**Draft Minutes of the 4th meeting of the Task Force on Studded Tyres
March 18, 2021 starting at 2:00 pm ending at 4:00 pm CET**

Dedicated Snow Grip Marking for Studded Tyres

Versions based on the comments expressed by the Experts in the
GRBP Task Force on Studded Tyres, March 18th, 2021.

Version 0.

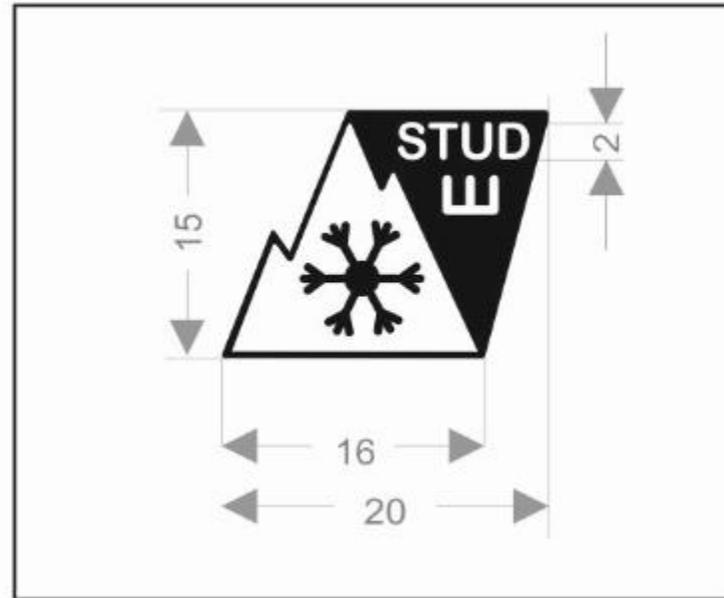
- the concept and visual idea is acceptable
- text/background (in the right-hand-side new triangle) should be allowed to be embossed either inwards or outwards from the tyre surface, at least to be looked at both versions
- good to maintain "family resemblance" with the Ice Grip Marking
- to be looked at versions with and without the word "STUD"
- to be looked at version with enlarged font size, with and without the word "STUD"
- to be added "molded in or out" into the text
- German MoT should be consulted about the acceptance of this marking concept
- to be added that the design dimensions are minimum dimensions
- to be checked if remolding of existing molds is possible
 - o *[Secretary's question: Why is this checking necessary because these two markings indicate that the tyres had been type approved*

- to be looked also a version where the new triangle is drawn only with a line

Version 1.

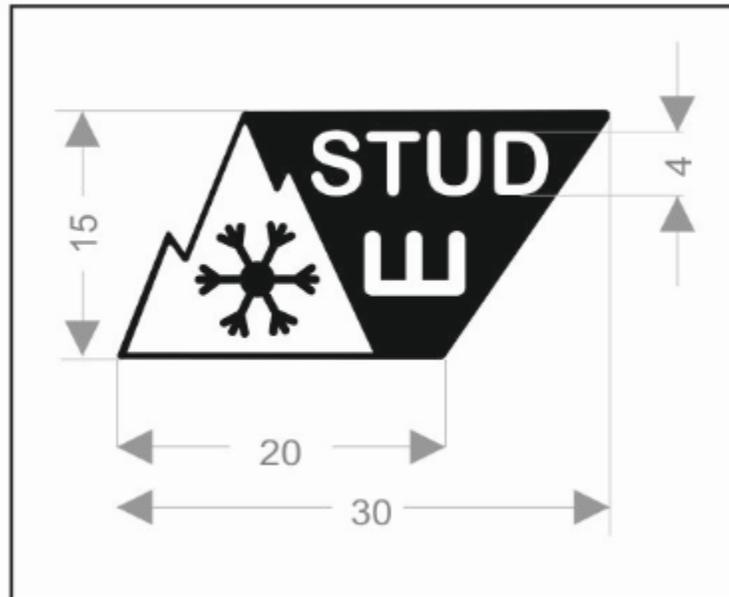
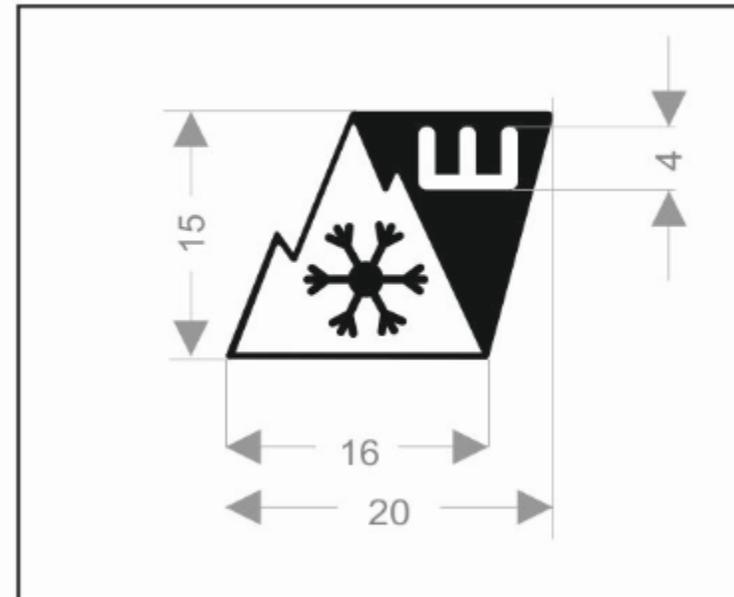
- font size 4 mm is clearly too large with the word "STUD"

Version 2.

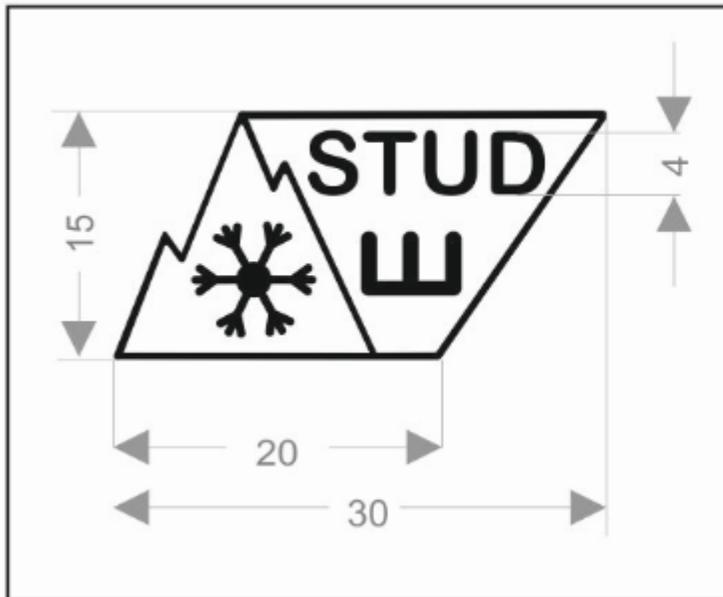
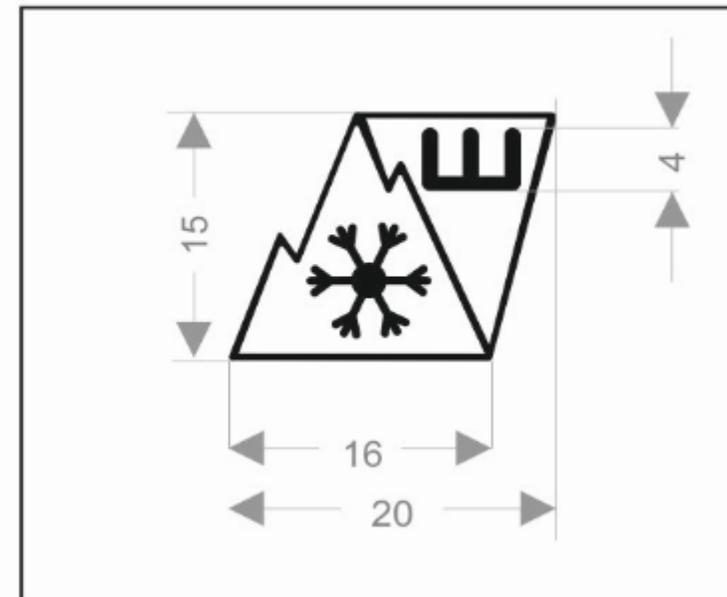
- font size 4 mm is too large with the word "STUD"
- embossing inwards is a relevant option

Version 3.

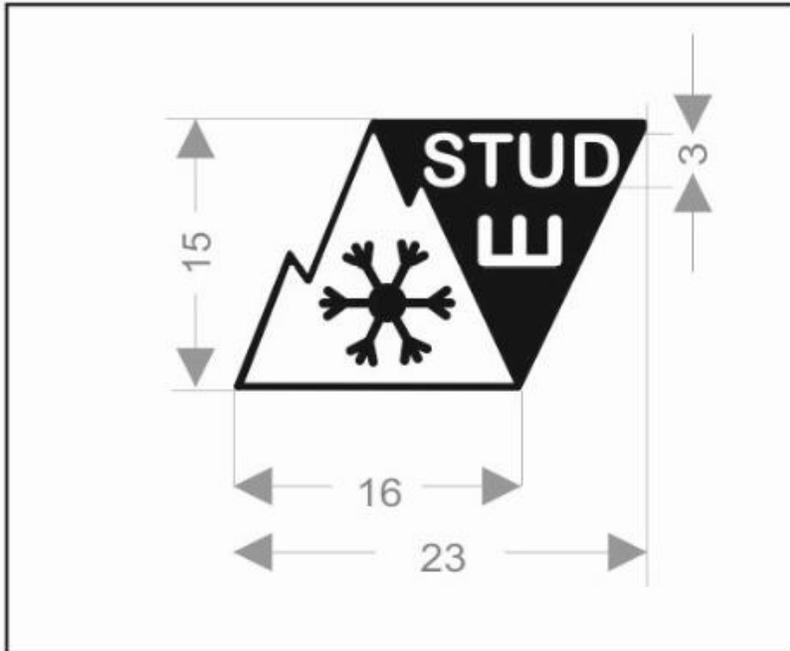
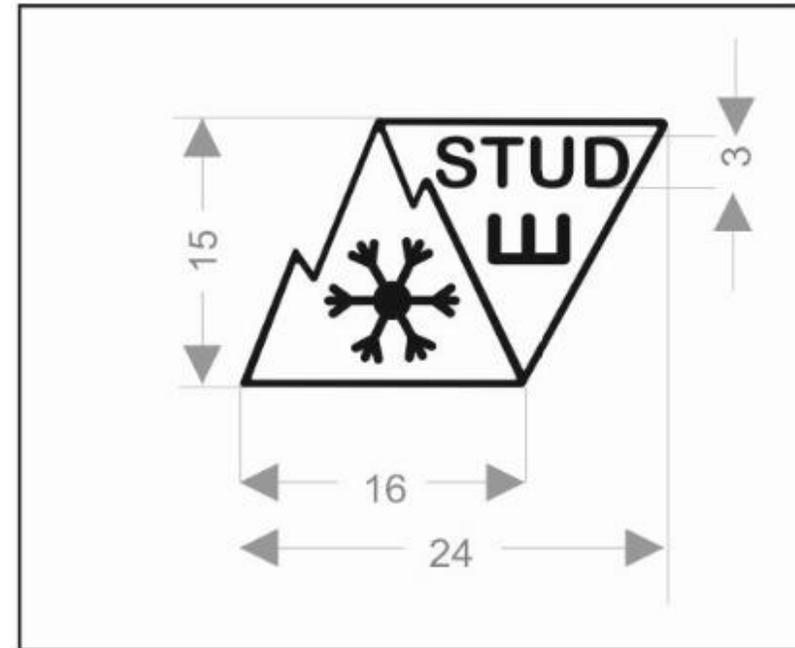
- font size 3 mm seems acceptable
- embossing addendum part inwards require extending the width from 23 to 24 mm

Comparison of the original and the latest versions

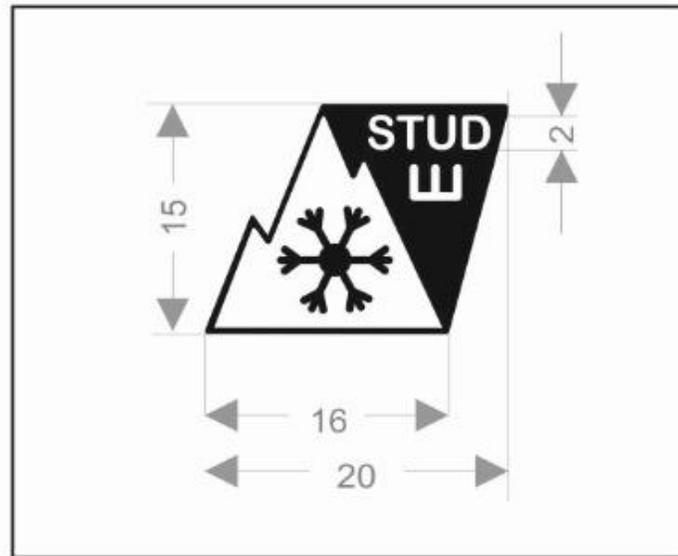
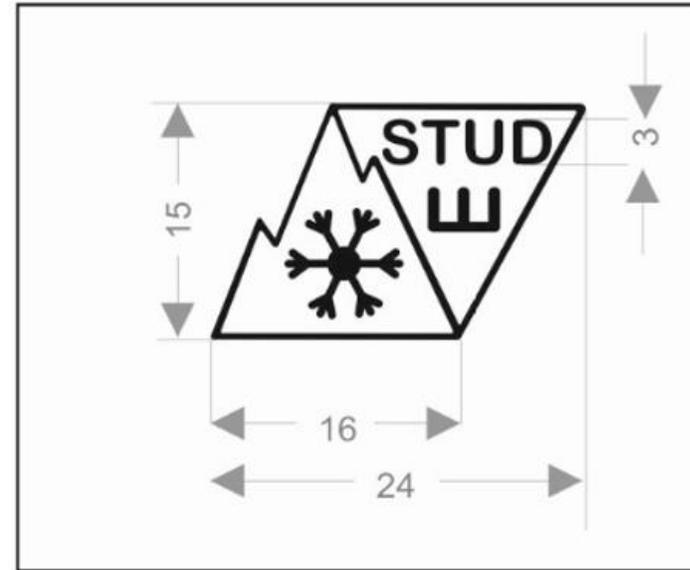
- font size 3 mm extends the width of the marking by 4 mm with a minimal benefit for readability.
 - Question: is it really practical to make the font size enlargement at all?
- embossing addendum part inwards require extending the width.
 - Question: does the inward embossing bring such added value that extending the width is justified?
 - Should not manufacturers be left with the freedom to choose whether emboss inwards or outwards?
